Product Change Notice (PCN)

PCN Number: PCN-0450007R-01

Product(s) Affected:
SJ-43504-SMT-TR

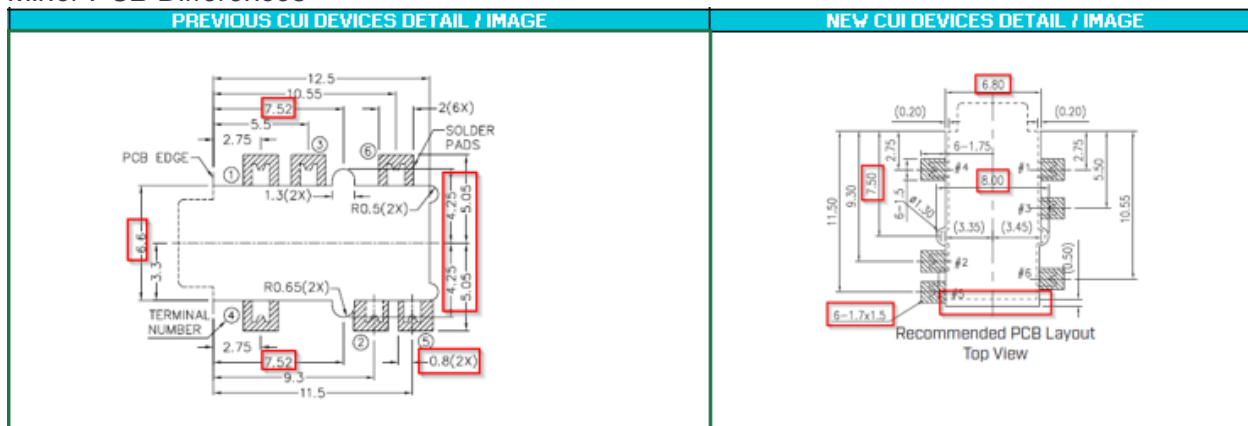
1. Minor Housing Differences

2. Minor PCB Differences
